Gore District Council Recommendation

OUTLINE PLAN APPROVAL

Application reference	OTHR26707
Requiring Authority	Minister of Education
Proposal	An application under Section 176A for an Outline Plan Approval for Phase 1 of the Māruawai College Senior Campus redevelopment, comprising an eight-classroom Specialist Technology Block and associated landscaping, site works and servicing.
Location	28 Coutts Road, Gore
Legal Description	Lots 21-23 Block II DP 87 and associated school lots within Designation D4
Designation	MEDU-1 – Education Purposes – Māruawai College Senior Campus
Recommendation	No changes requested
Date	24 July 2026

7 Soak Pit Details
301 1:20@a1 1:40@a3

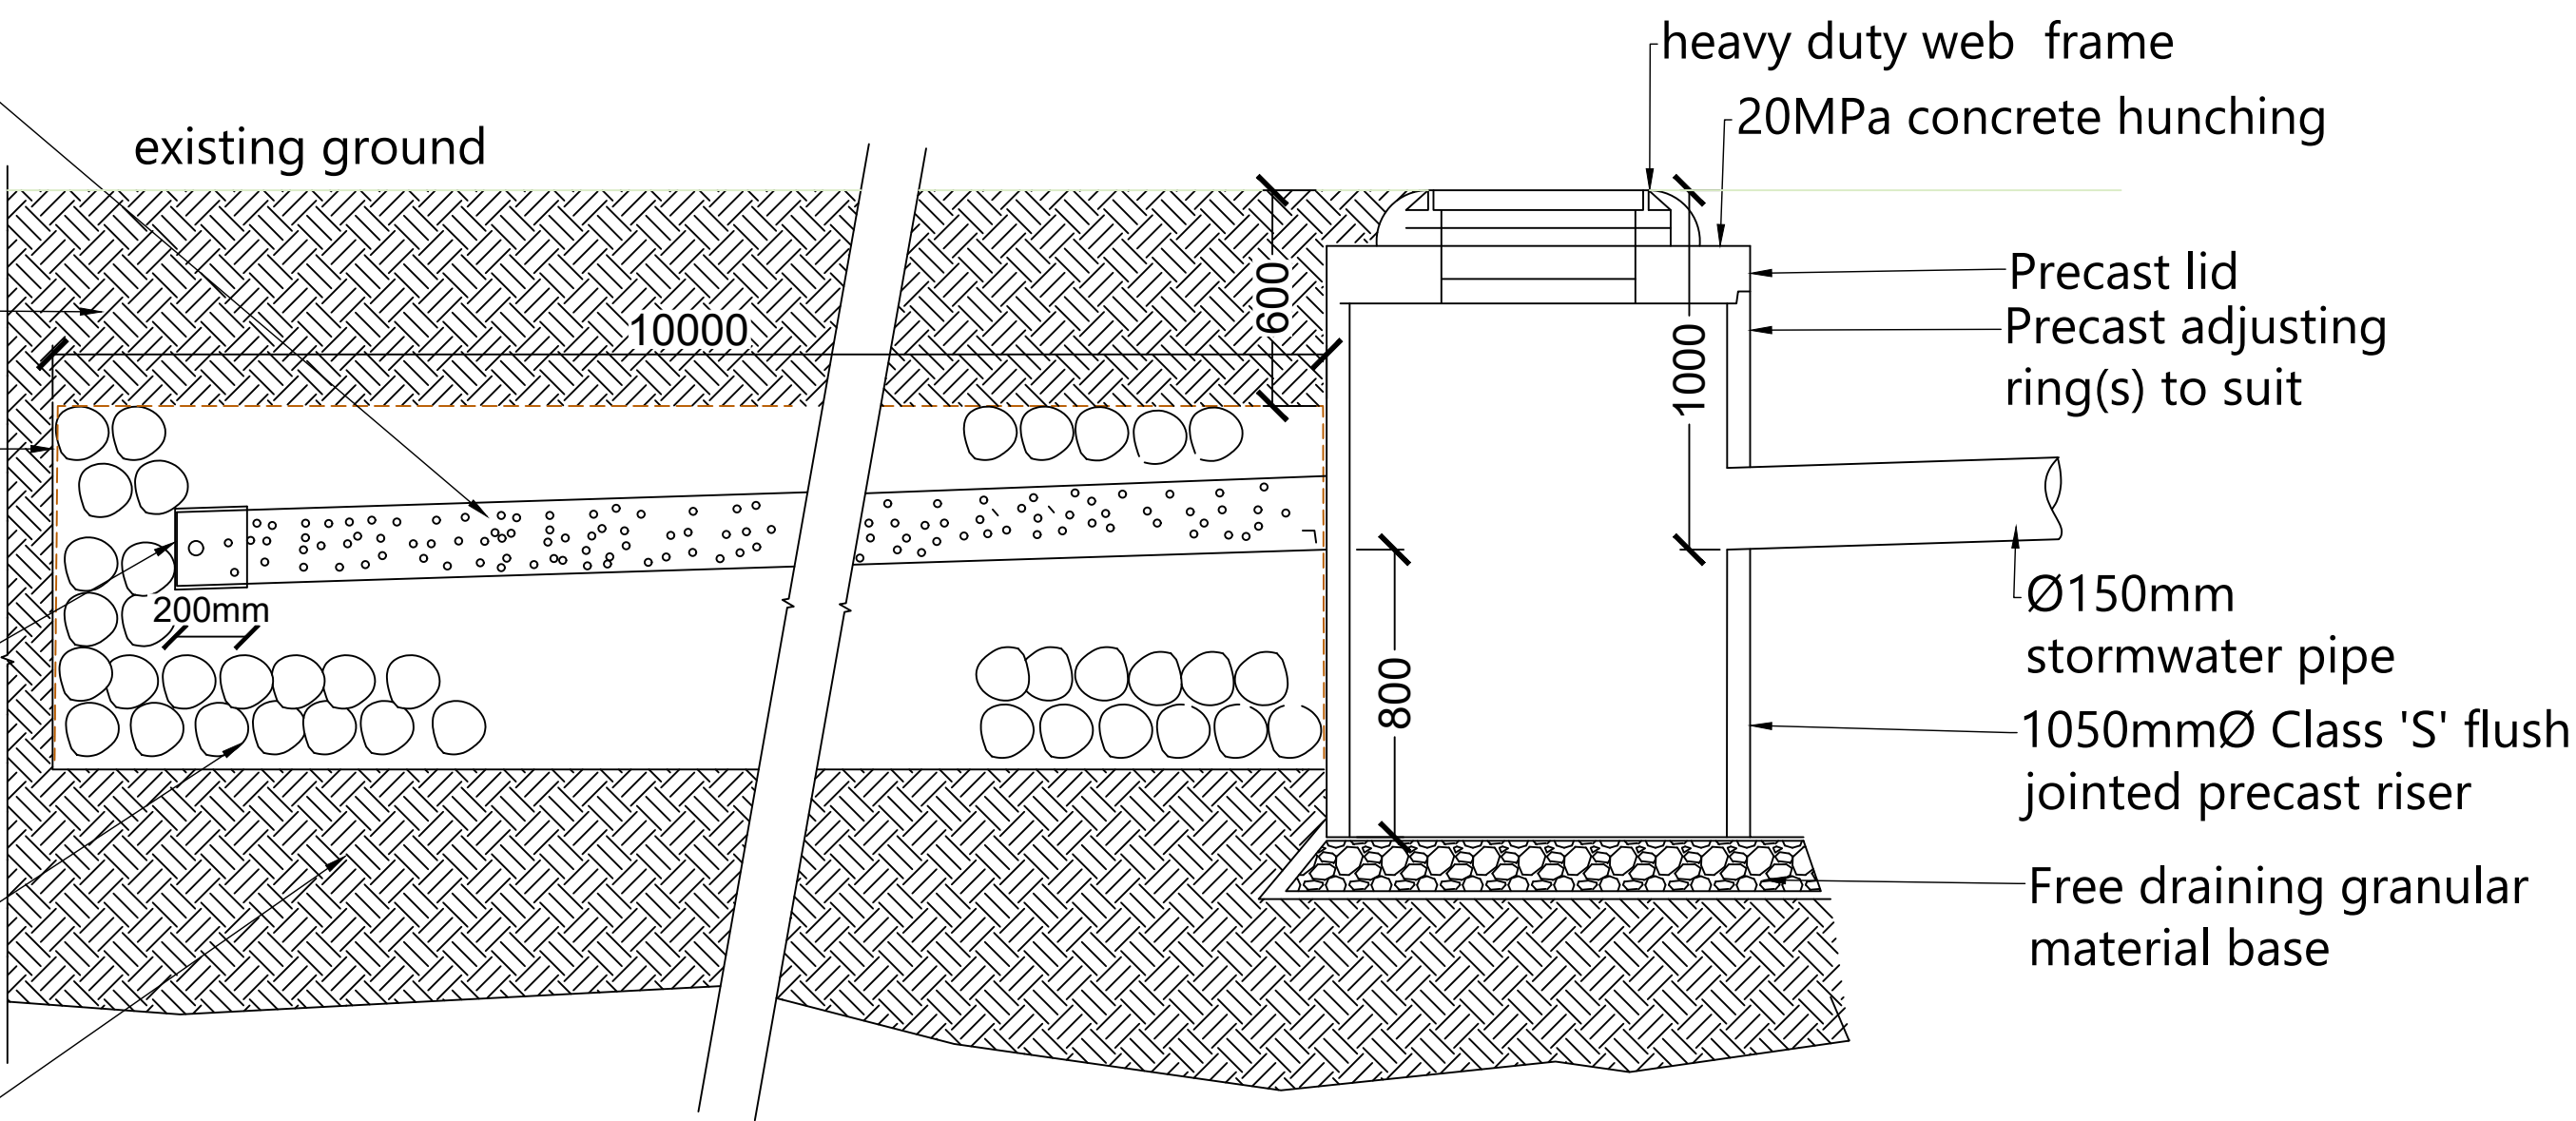
- Stormwater that previously discharged to the combined stormwater and wastewater system will be separated and discharged to an onsite soakage system. The Civil Stormwater Plan shows a soak pit approximately 10m long, 3m wide and 1m deep. Three Waters considers this a positive outcome and has no further comments.
- The new building will use the existing wastewater connection, with no further wastewater matters raised.
- The existing 150mm water ring main serving fire hydrants will be realigned around the new building and existing hydrant will be relocated. A new 40mm water connection, gate valve, meter and backflow preventer are also proposed. The Civil Water Supply Plan identifies a Wilkins 375 backflow preventer, or a similar Council approved device, within a weatherproof enclosure.

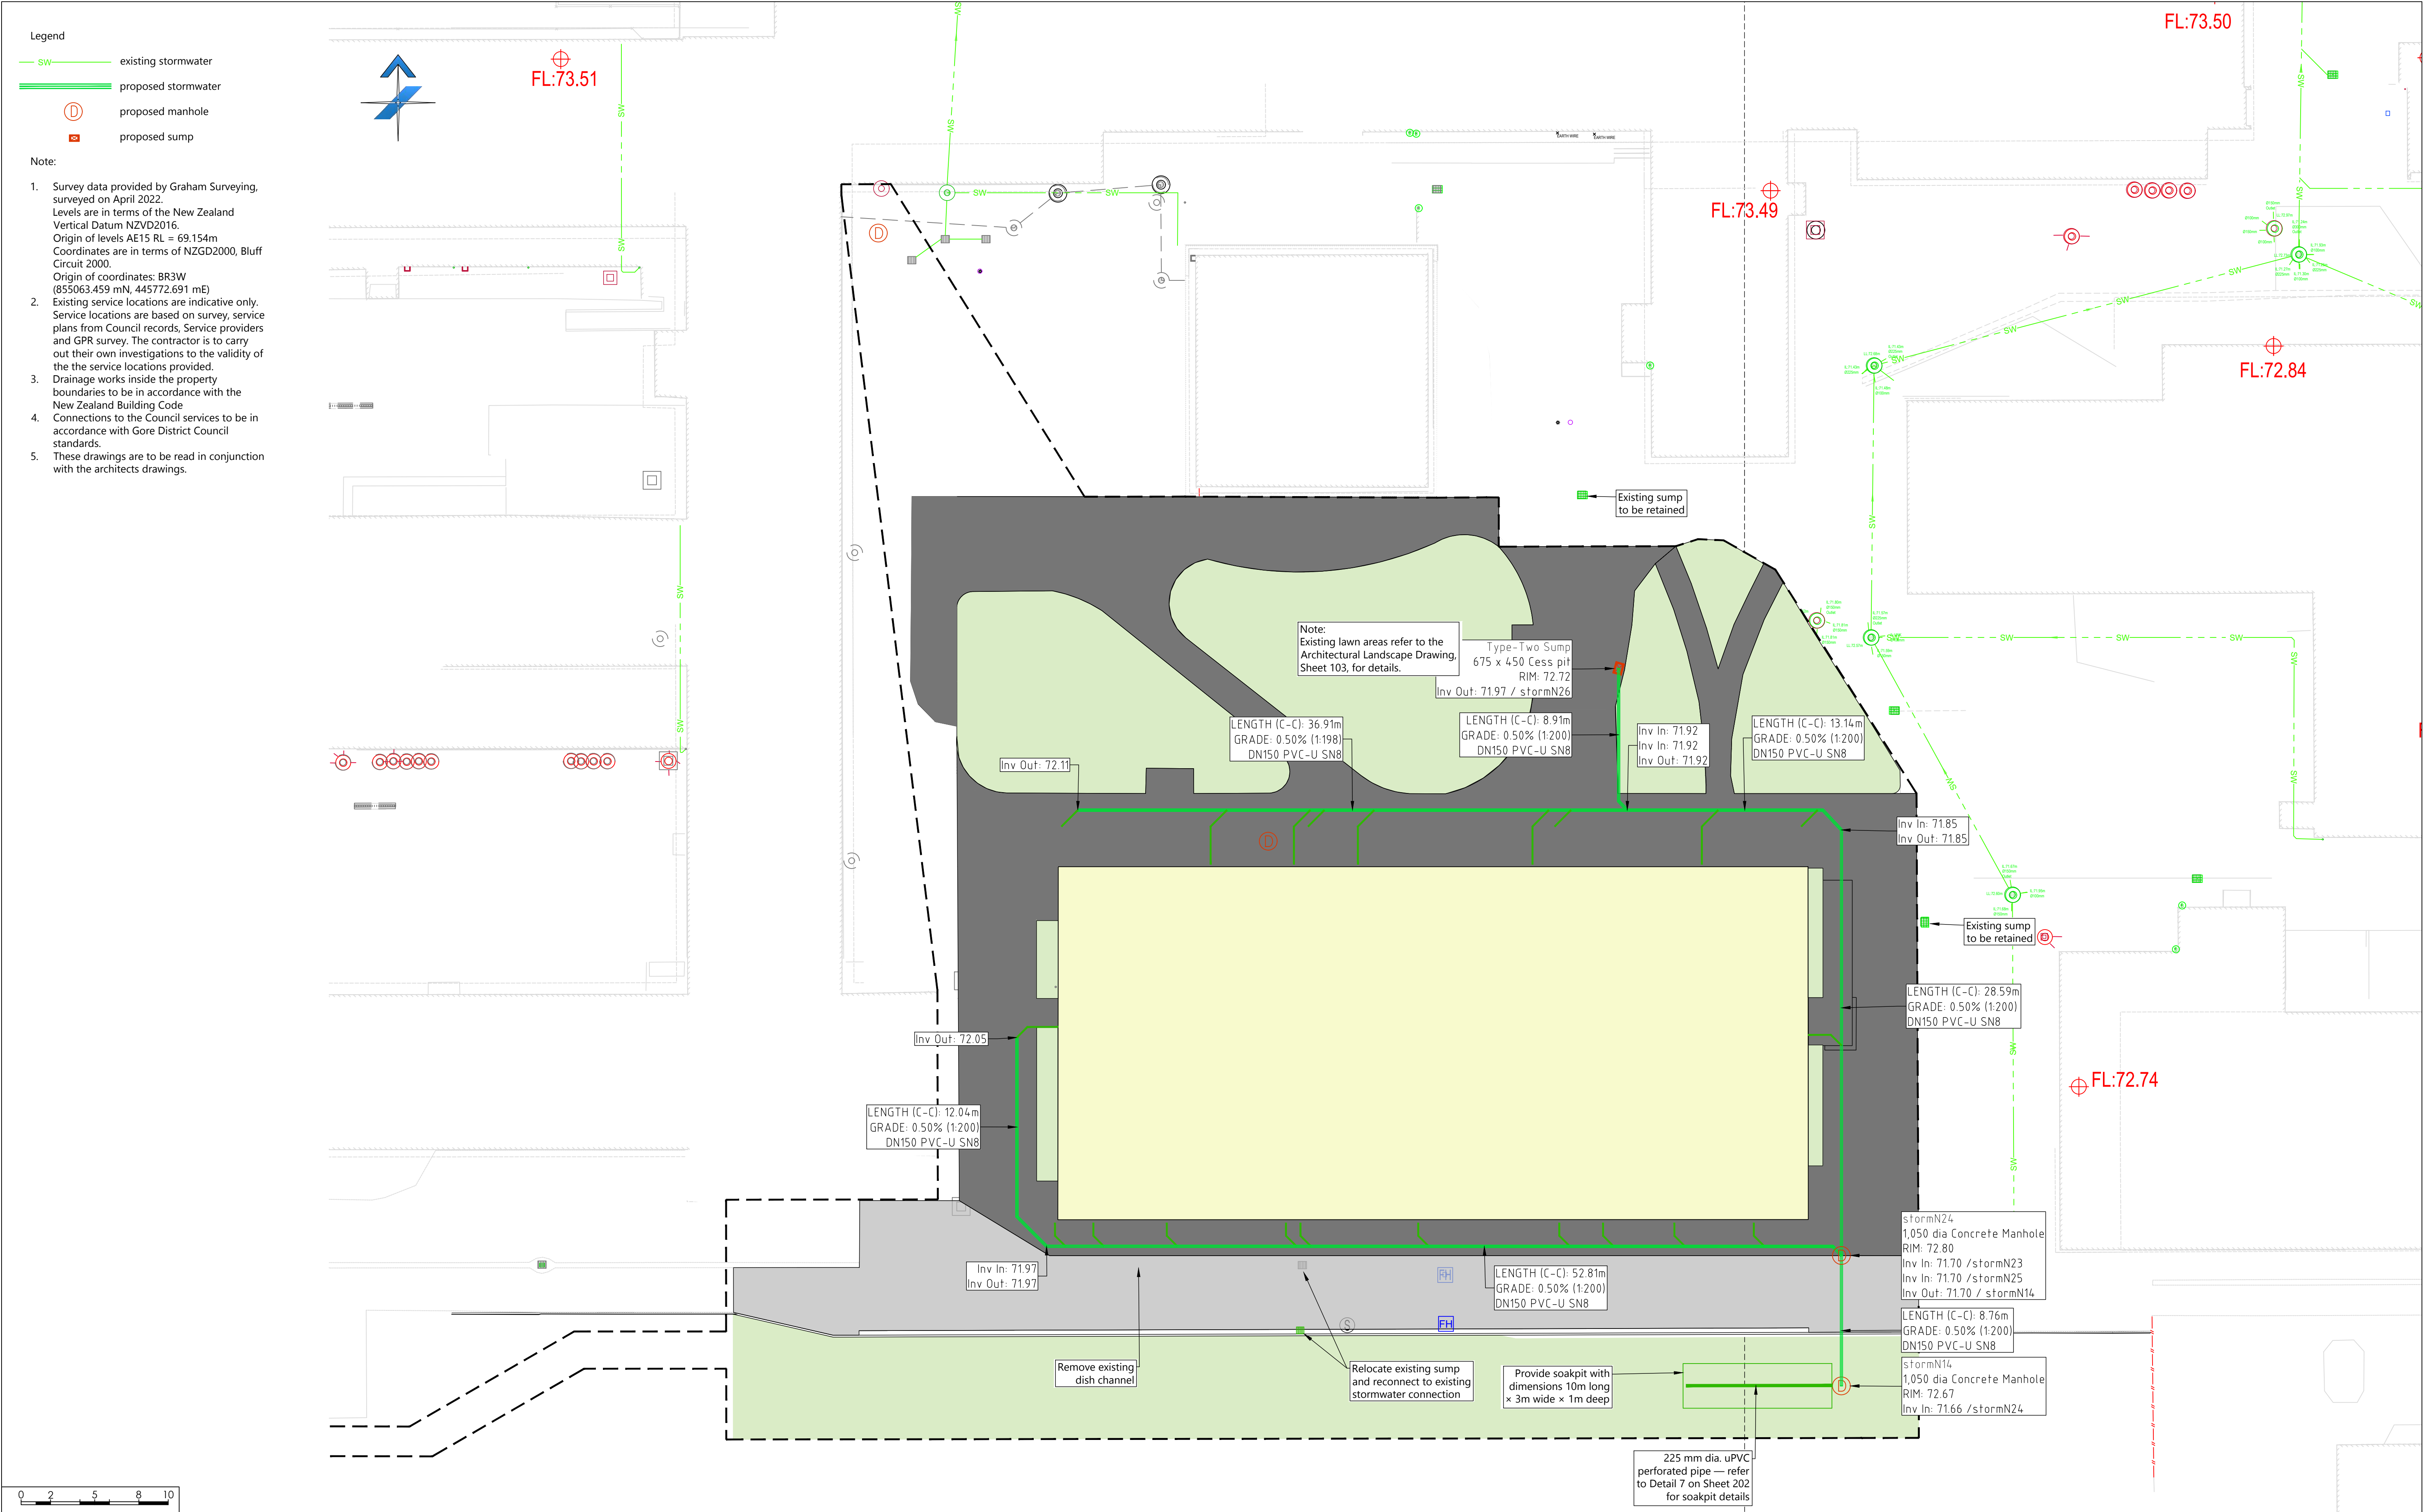
Building Services has noted that the submitted drawings identify the soakage layout but do not themselves contain the site-specific design storm, tested soakage rate or soakage calculations needed to demonstrate compliance with NZBC E1. Those detailed calculations are being considered through

Building Consent 211731. The outline plan is not the mechanism to determine Building Code compliance. For the purposes of section 176A(3)(f), the drawings identify a defined onsite stormwater solution, the proposal removes stormwater from the combined network, and the relevant asset manager has raised no servicing concerns. No change to the Outline Plan is therefore required, but the requiring authority remains responsible for obtaining building consent and demonstrating adequacy of the soakage design through that process.

- Building Consent 211731 must address the detailed onsite stormwater disposal design, including the applicable design event, site-specific soakage testing and calculations, overland-flow management and compliance with NZBC E1.
- The final backflow-prevention device must be a model approved by Council and installed in accordance with Council requirements.
- Any works within the road corridor require a Corridor Access Request, an approved Traffic Management Plan and a Council-approved roading contractor. Damage to vehicle crossings caused by construction traffic must be repaired to Council's satisfaction at the requiring authority's expense.
- No listed / notable tree removal or works within the dripline of a listed / notable tree are authorised by this approval
